**ALBERTA TRANSPORTATION
SPRINGBANK OFF-STREAM RESERVOIR
PROJECT
Response to NRCB and AEP
Supplemental Information Request 2,
dated November 18, 2019**

Prepared for:
Alberta Transportation

Prepared by:
Stantec Consulting Ltd.

April 2020

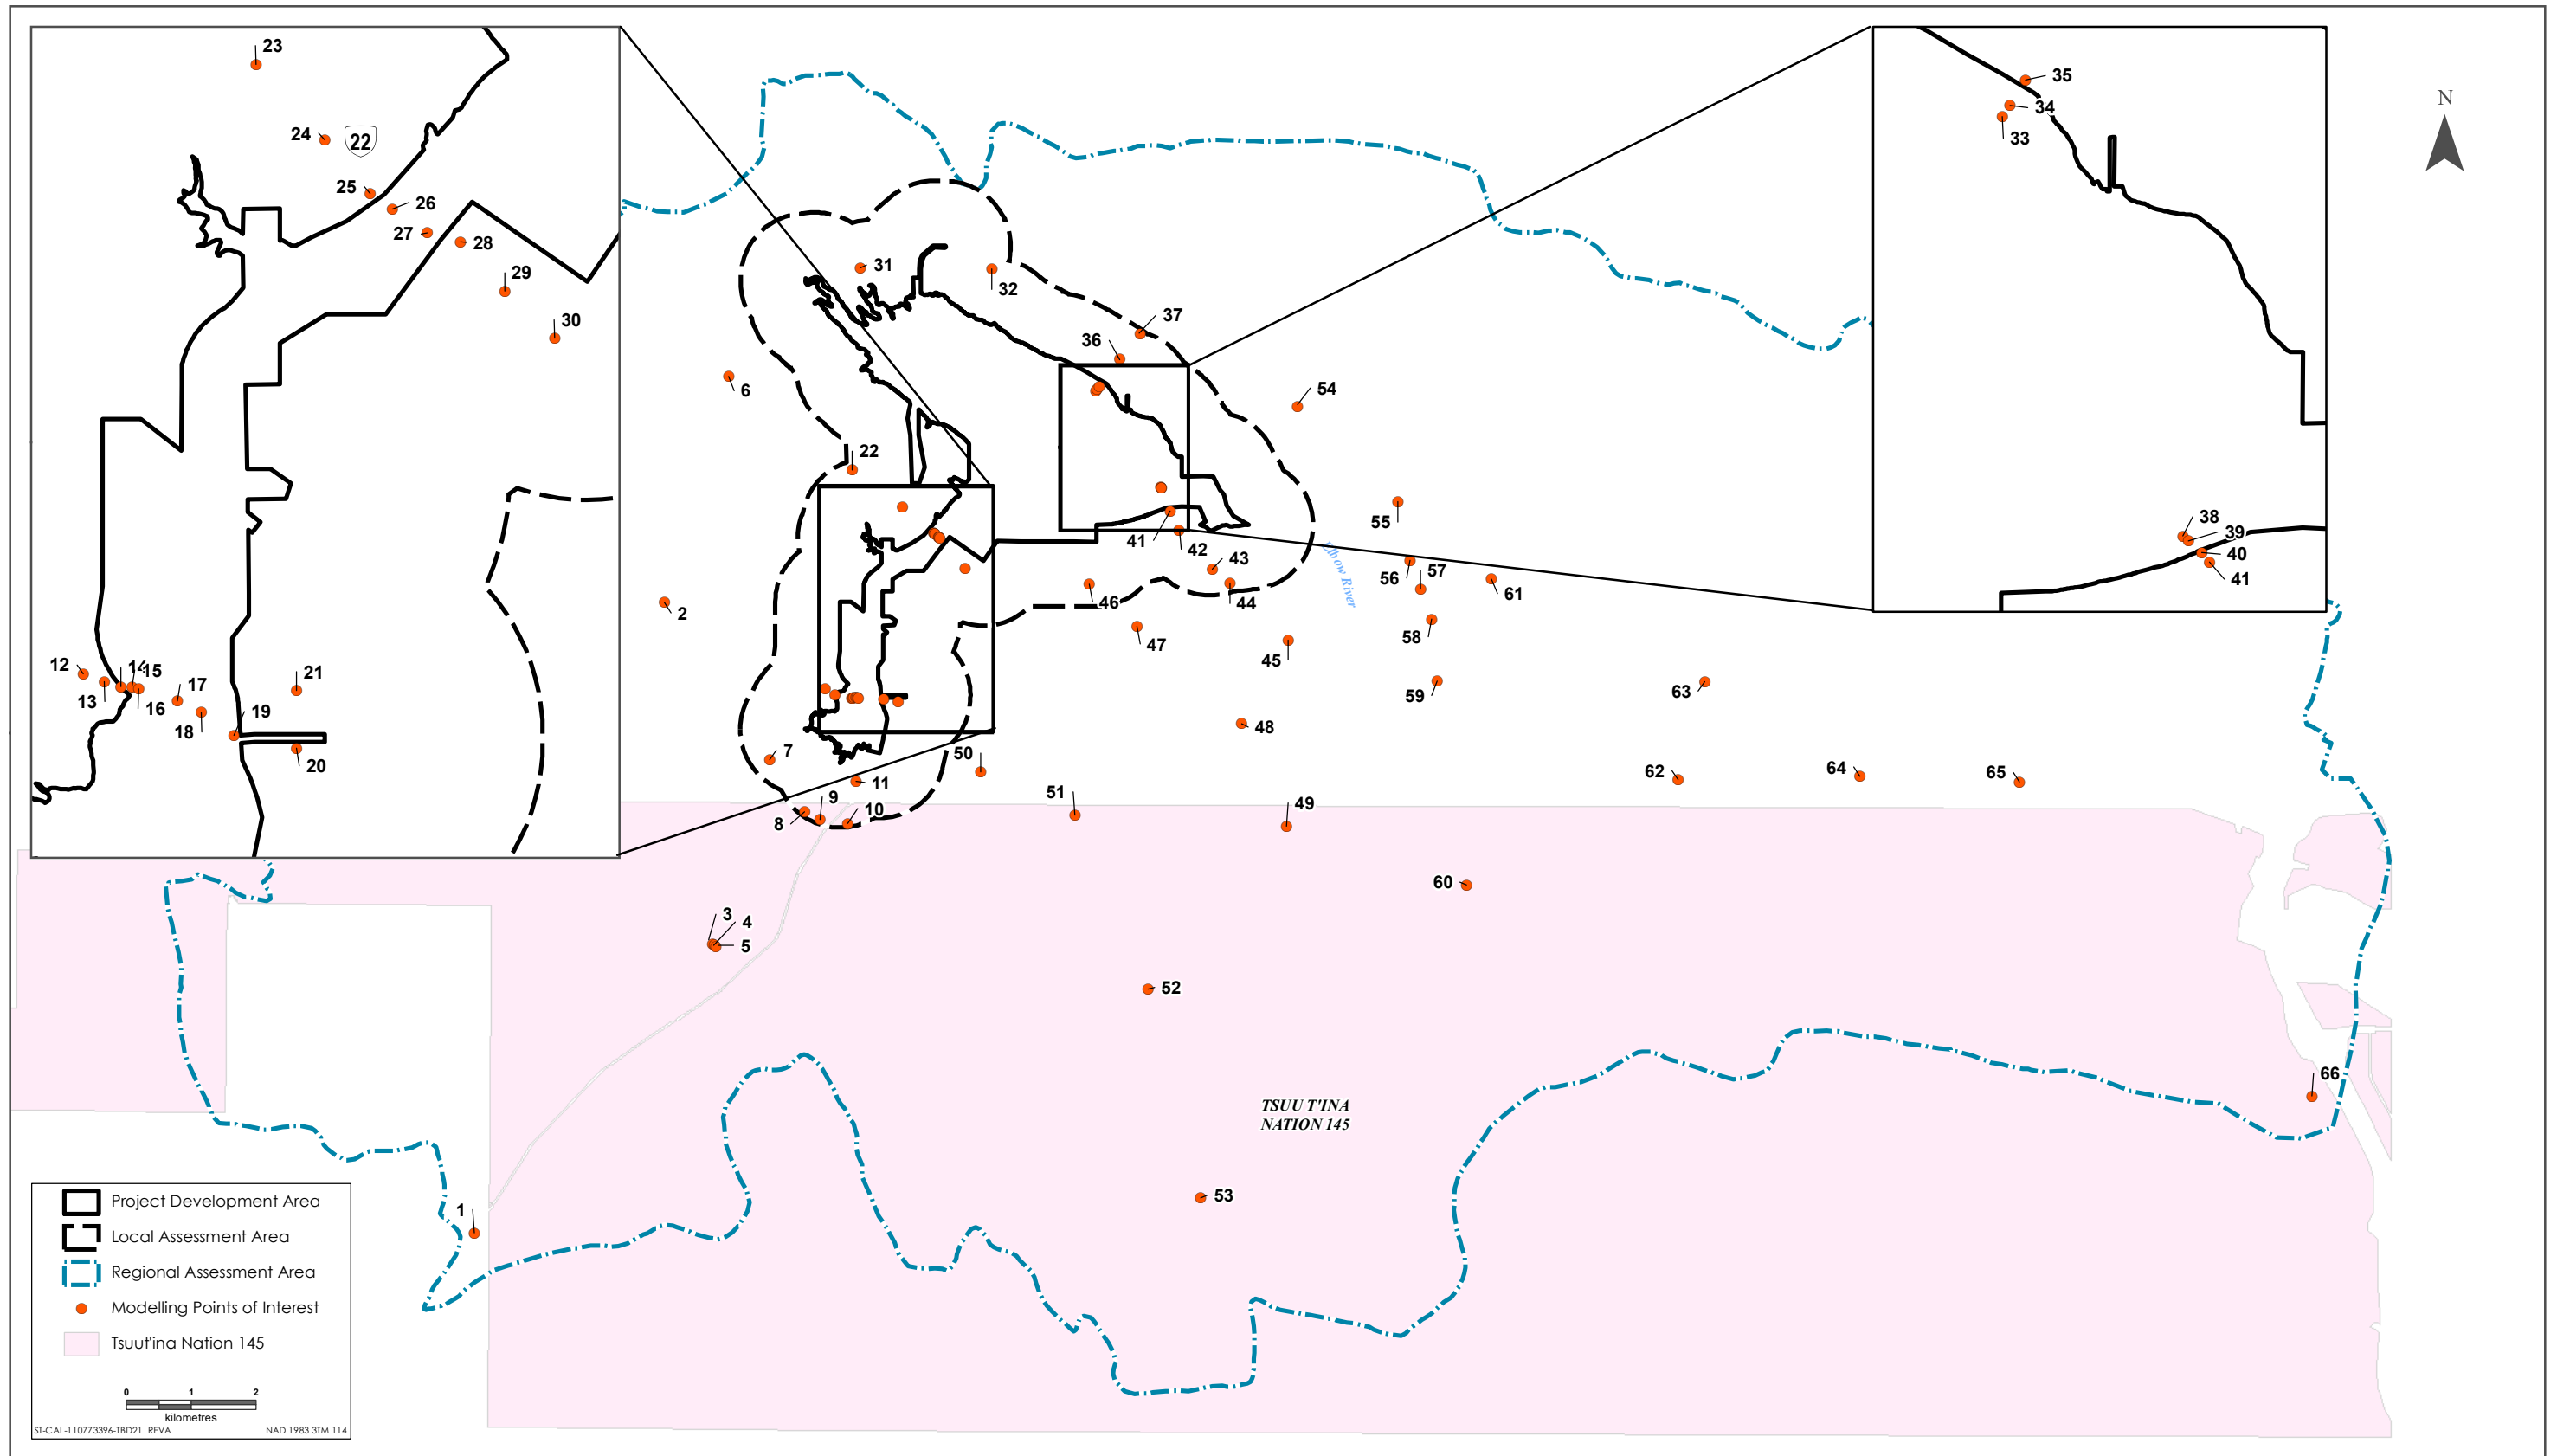
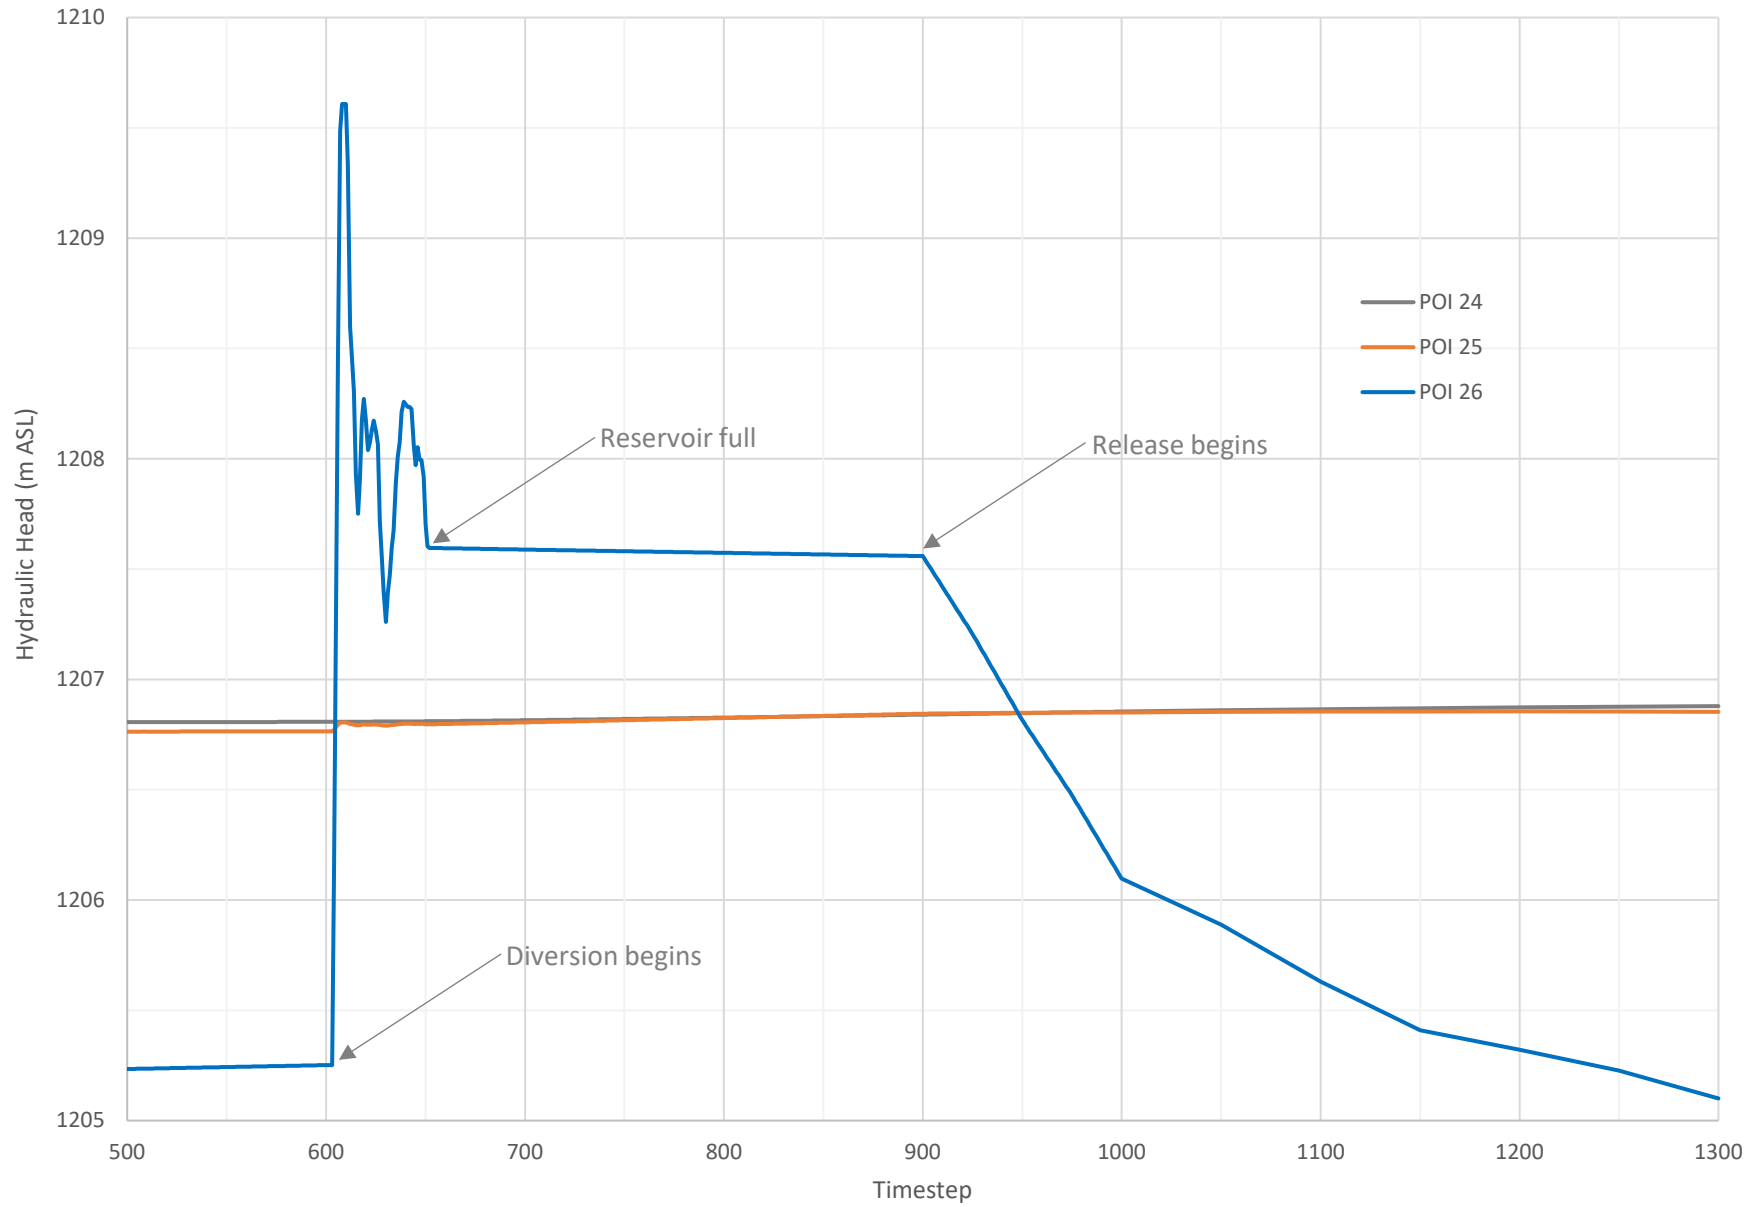
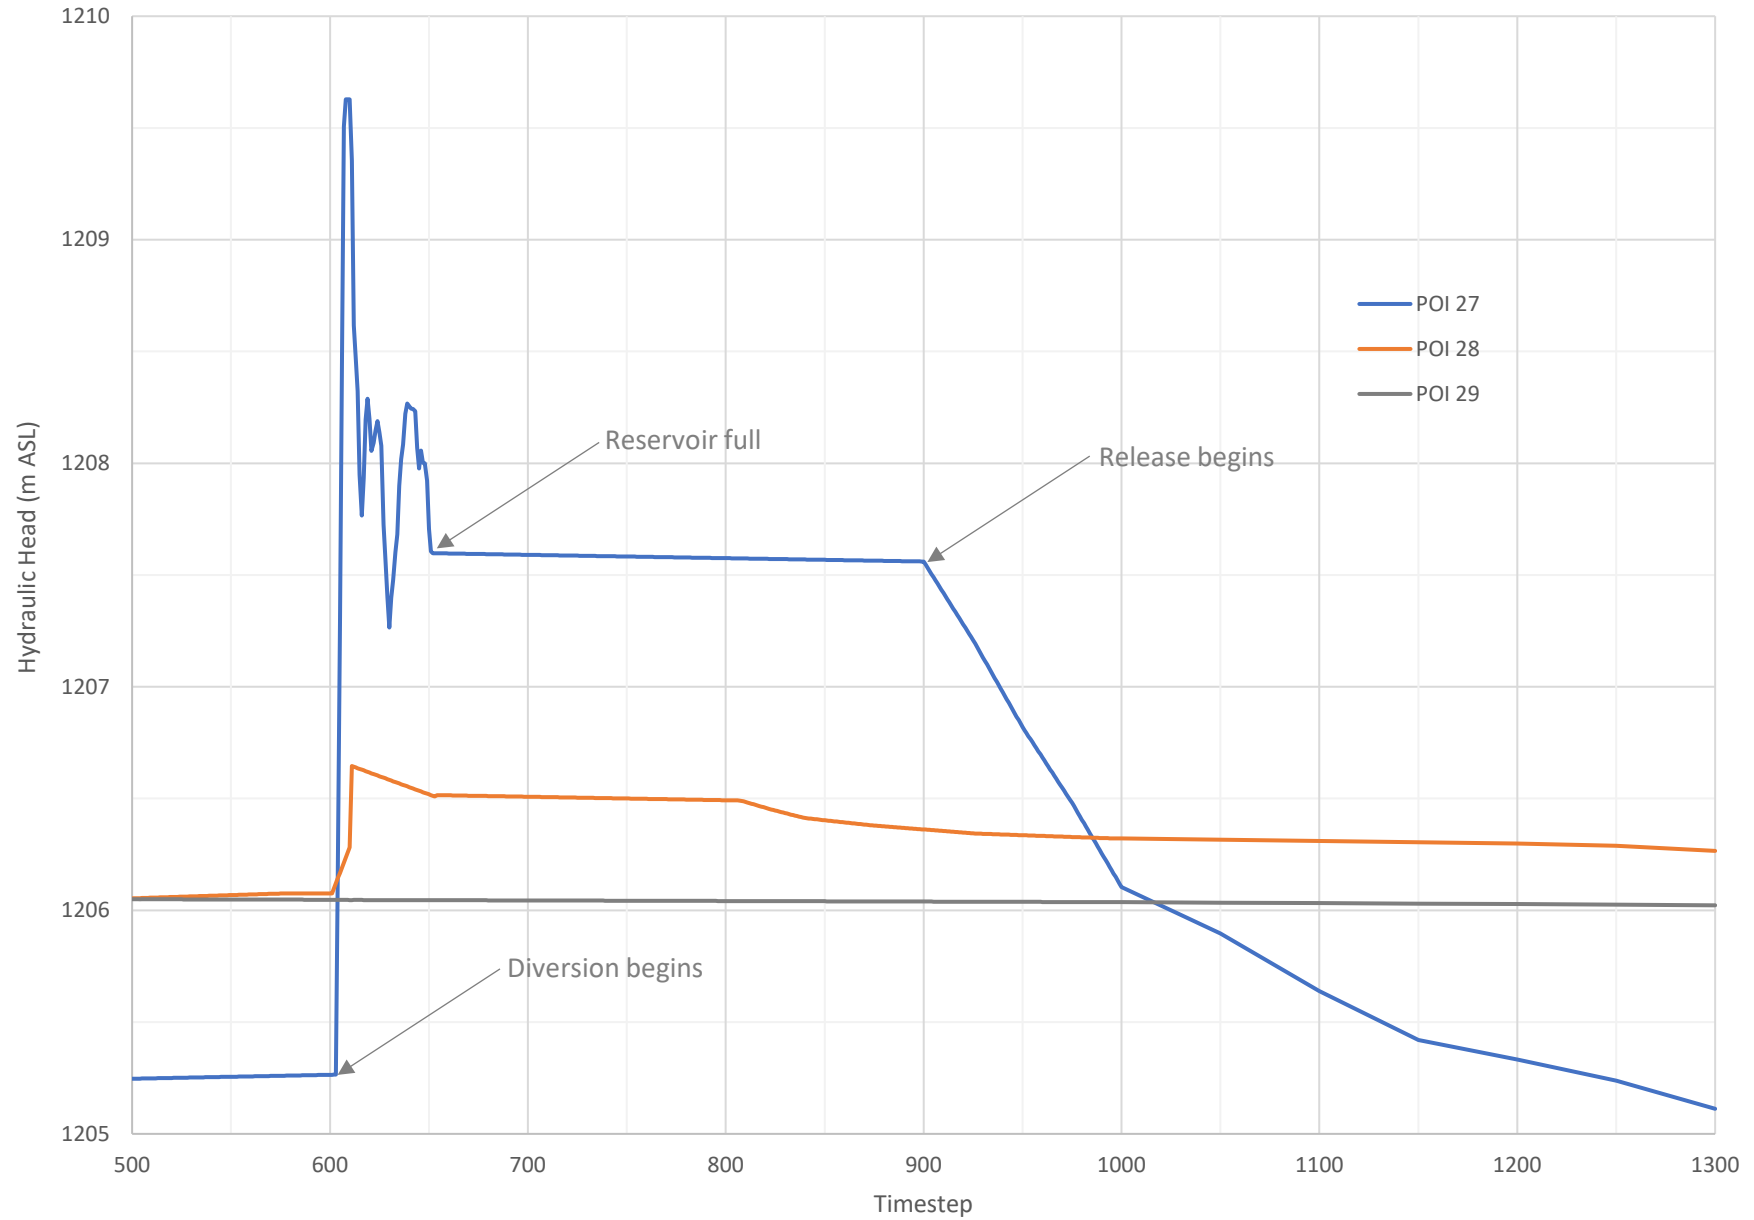
No time series plots are provided for the Points of Interest in Appendix IR42-1, Figure 5-4.

a. Provide the plots requested in Question 258.

a. Figure 9-1 presents the locations of the points of interest (POI). The following discussion presents time series hydrographs for POI in areas near the diversion channel and reservoir. All timesteps referenced in Figure 9-2 to Figure 9-6 are one-hour increments of elapsed time since the start of the simulation for the design flood.

Figure 9-2 presents hydrographs for three POI (24, 25 and 26) near the north side of the diversion channel. Point 26 shows the response to water levels in the channel resulting from the diversion of water from Elbow River. Point 25 is located approximately 10 m north of Point 26 and shows a delayed and dampened response, increasing approximately 4 cm beginning at timestep 605, followed by a gradual increase of 6 cm by timestep 1,300 (the end of the simulation). Point 24, located approximately 20 m from the channel, shows further dampening with effectively no response immediately after the diversion begins, followed by a lagged 8 cm increase by timestep 1,300.

Figure 9-3 presents hydrographs for POI on the south side of the diversion channel. The results are similar to observations for the north side of the diversion channel, although a more immediate and higher magnitude response is observed at the nearest point (Point 27) to the channel. Point 27 on the south edge of the channel shows the water level response due to the diversion of water within the channel. Point 28 is located approximately 10 m from the channel and shows a dampened response, increasing a maximum of 60 cm between timestep 605 and 616, but decreasing over the remainder of the simulation. At Point 29, located approximately 20 m from the channel, no response to the diversion of water is observed.

Figure 9-4 presents hydrographs for POI on the southeastern edge of the off-stream reservoir. Point 38 shows the response to the reservoir water reaching a maximum level of 1,207.3 m asl during the design flood, and following release of the water, remaining near the ground surface after the design flood has passed (to simulate continued near surface saturation). At Point 39, located approximately 10 m from the reservoir, an increase in hydraulic head of 2.1 m is followed by a gradual decrease (once water is released after the design flood) over the remainder of the simulation. Further dampening of effects on water levels is observed away from the reservoir, with only approximately 0.30 m of change at Point 40, located

Figure 9-5 presents hydrographs for POI on the northeastern edge of the reservoir. Point 33 shows the response to retention of water when the reservoir water reaches a maximum level of 1,207.3 m asl (during the design flood) and remaining near the ground surface after the design flood has passed. At Point 34, located approximately 35 m from the reservoir, a maximum increase in hydraulic head of 0.56 m is followed by decreasing levels after the design flood has passed for the remainder of the simulation. Further dampening is observed away from the reservoir, with essentially no change in water levels noted during the design flood at Point 35, located approximately 90 m from the reservoir.

Figure 9-6 presents hydrographs for POI near Elbow River south of the LAA. Hydraulic head changes are observed in the alluvium as a result of changes in river stage during the design flood. Point 3, adjacent to the river, shows the response to the specified head over the transient flooding simulation. Point 4 and Point 5 show an initial increase between timestep 500 to 600 when the simulation is adjusting from the steady state hydraulic head values to the transient head values specified for the river. Following the initial increase, the dampening effect is observed in the sand and gravel aquifer at distances of 30 m and 60 m from the river, respectively.
